AGENDA PORTLAND PLANNING BOARD MEETING

The Portland Planning Board will hold a meeting on Tuesday, September 10, 2019, Council Chambers, 2nd Floor, City Hall, 389 Congress Street. **Public comments will be taken for each item on the agenda during the estimated allotted time and written comments should be submitted to planningboard@portlandmaine.gov.**

Memorandum
Planning and Urban Development Department
Planning Division

To: Sean Dundon, Chair and Members of the Portland Planning Board
From: Christian Roadman, Planner
Date: September 6, 2019
Re: 130 Morning Street Residential Development
Project #: PL-000732-2019 CBL: 014 K007
Meeting: September 10, 2019

Northeast Elevation (E)

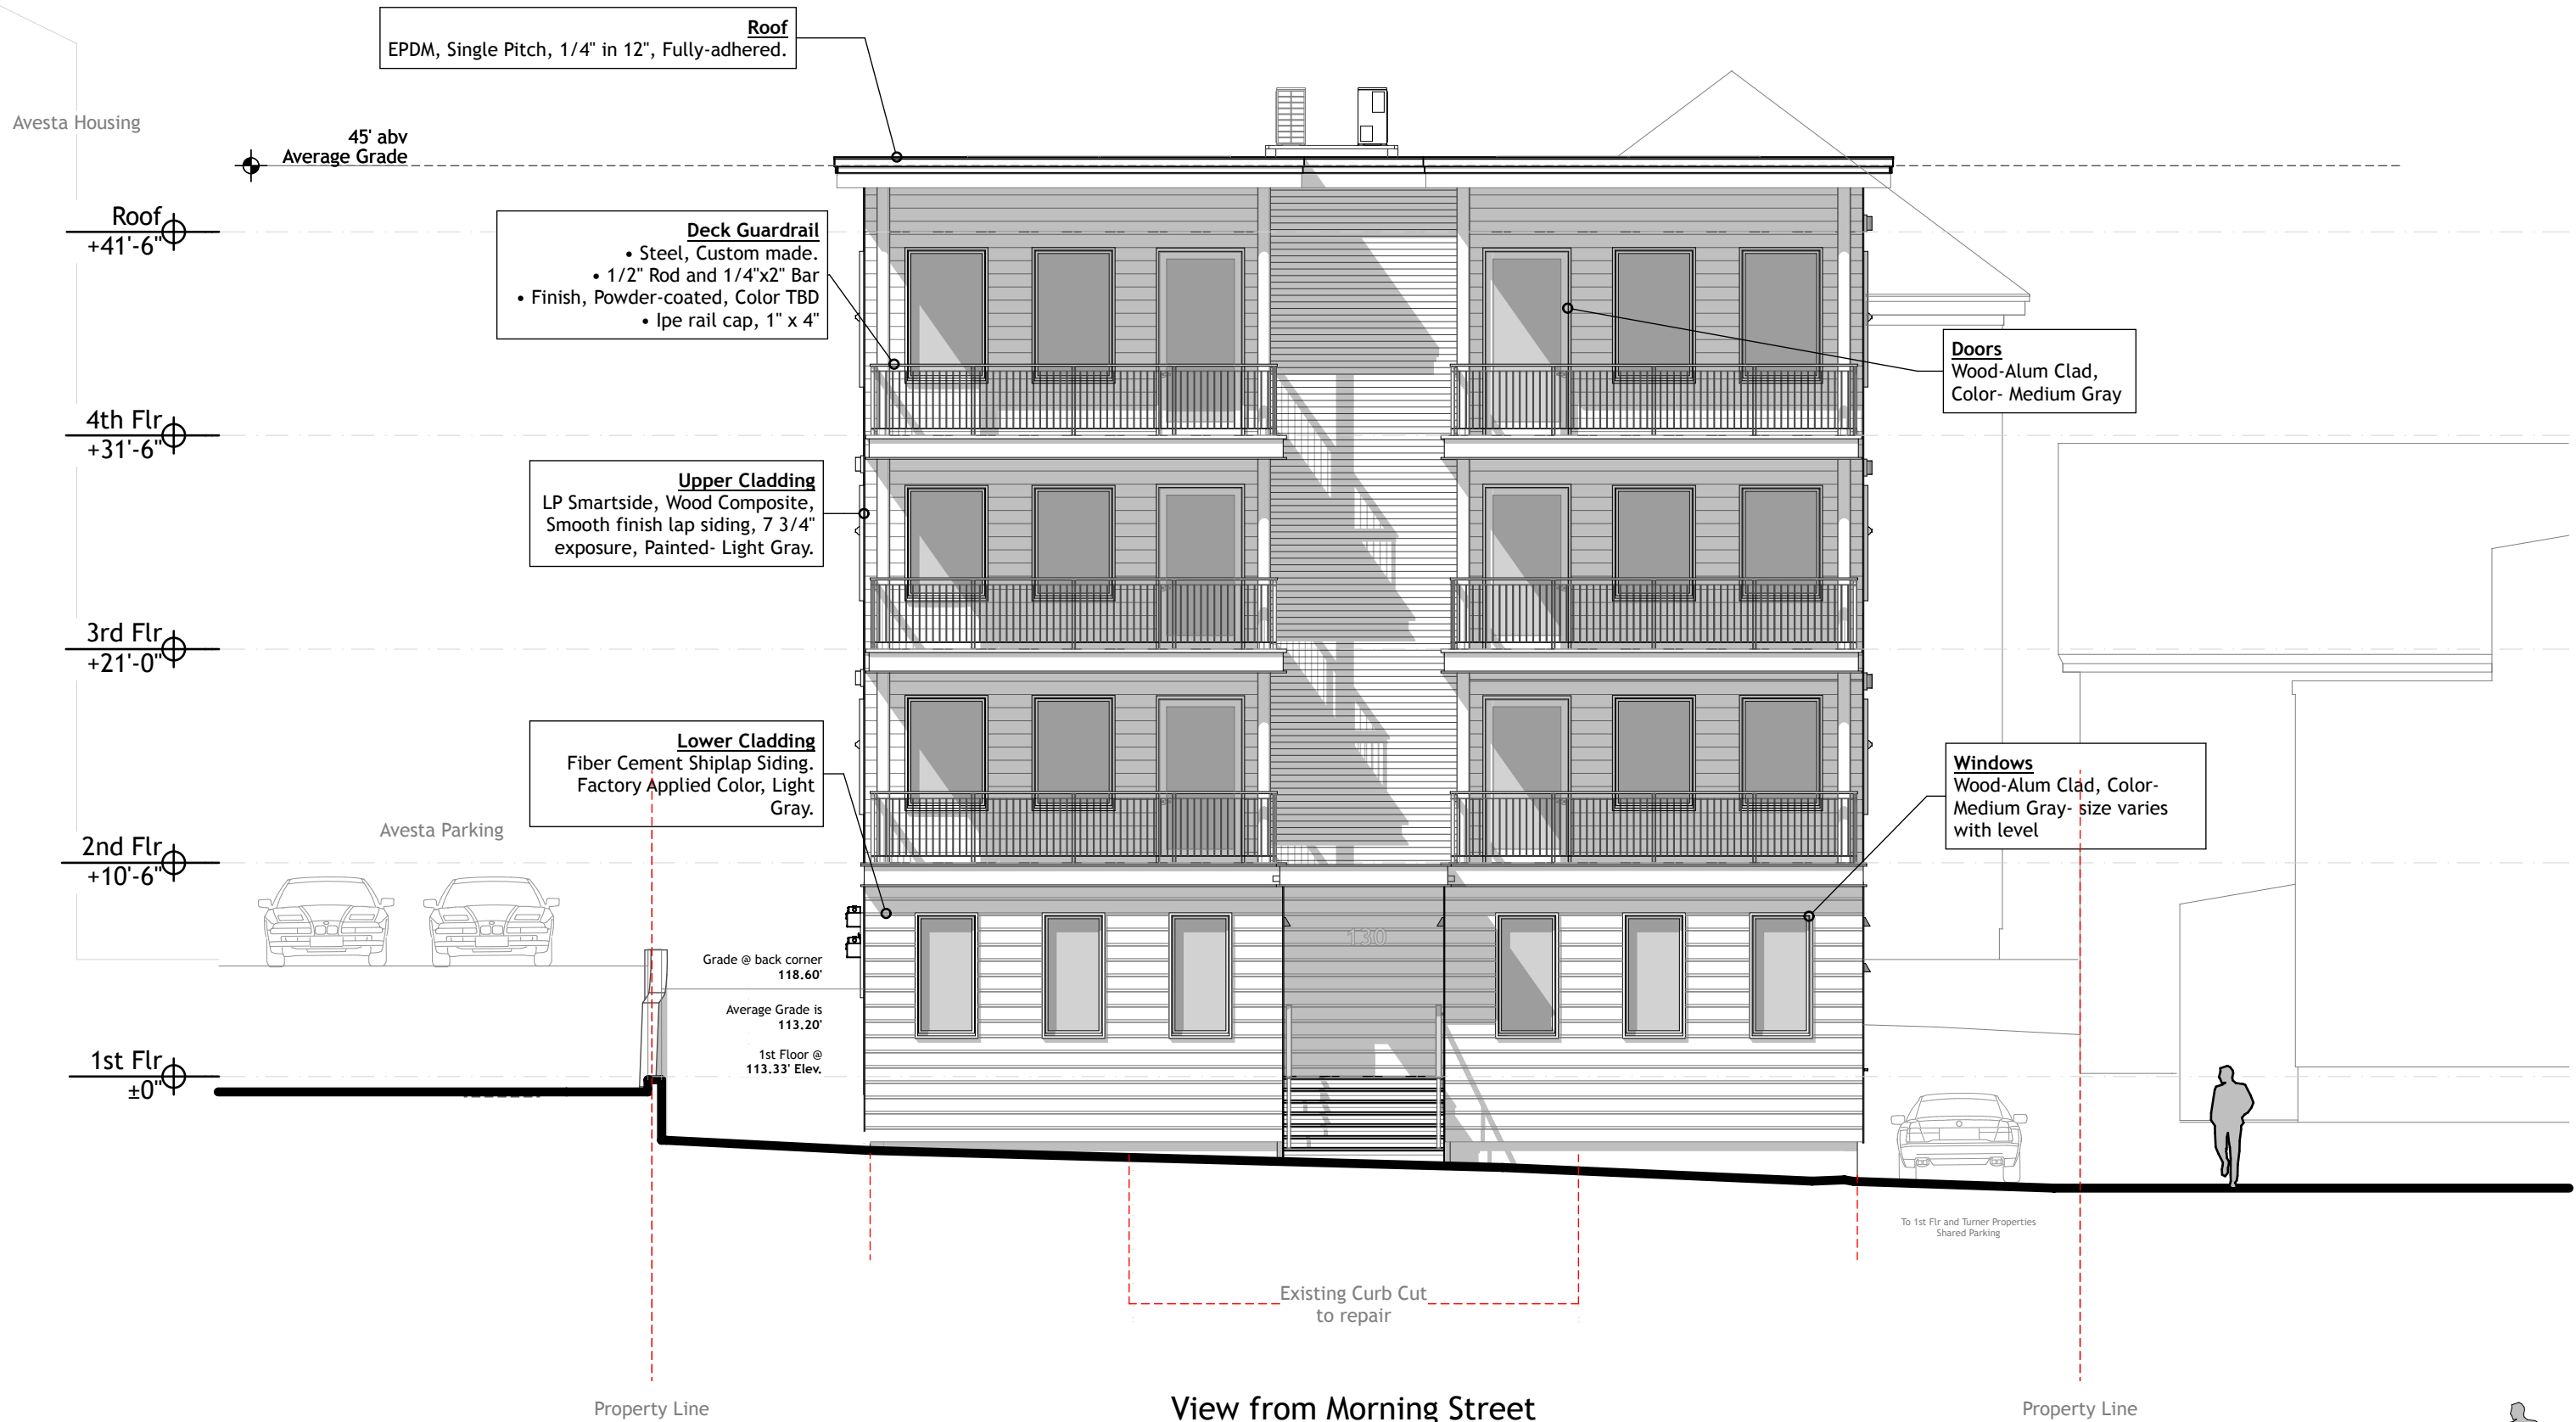
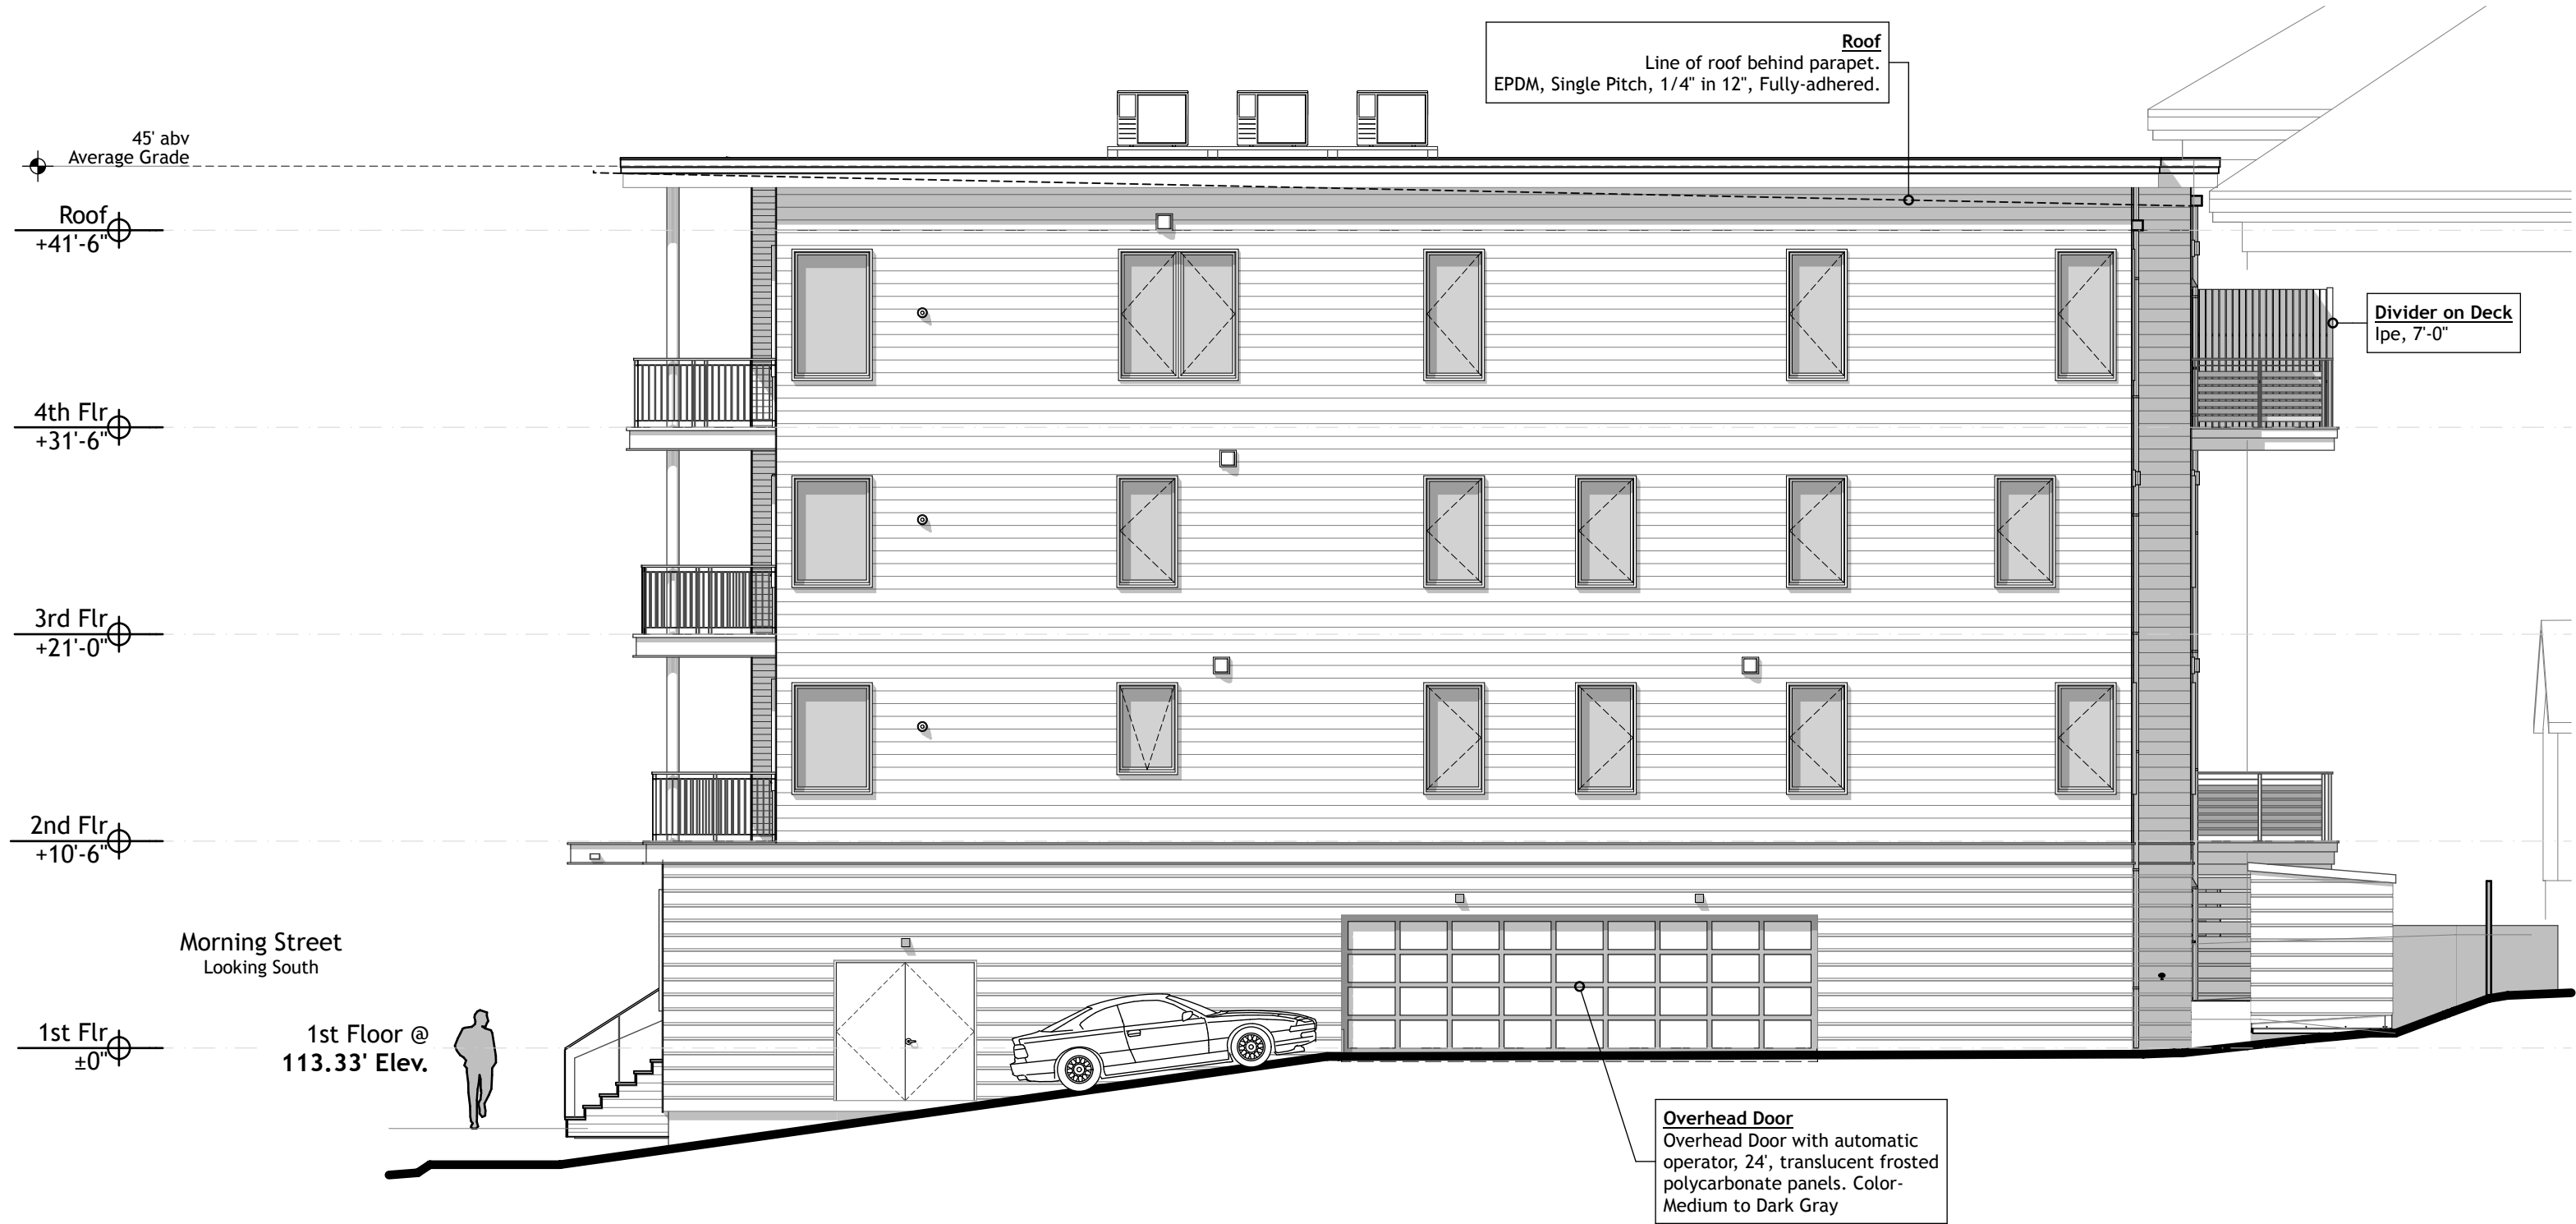
The proposed plan partially conforms to zoning requirements, with some potential required modifications. Rooftop appurtenances, including the parapet, appear to exceed the 45' required maximum height in provided elevations (attachment P15). An updated landscape plan is required and should be used to calculate the landscaped open space requirements. The applicant's current calculation of the open space requirement is unclear given a reference to further calculations on the site plan (attachment P5).

- Roof Form/Appurtenances: The rooftop mechanicals appear to now be positioned taller than the previous version – please explain the revisions to the roofline and these elements.
Suggested Revision: Potentially change the roof line, raise a parapet to create a unified, integrated roof form that also conceals these rooftop appurtenances. Rooftop mechanicals are limited to 5' max above 45' height limit and must be screened per zoning.

Response – Please refer to the revised architectural drawings. The Architect has added a rear parapet to shield the PV panels and condensers on the roof from view from the far side of Emerson street at street level. See sheet R5.

Northeast Morning LLC - Roof Edge cornices were thickened with a Parapet to help hide roof top PV panels and centrally located condenser appurtenances. See sheet R1-R5.
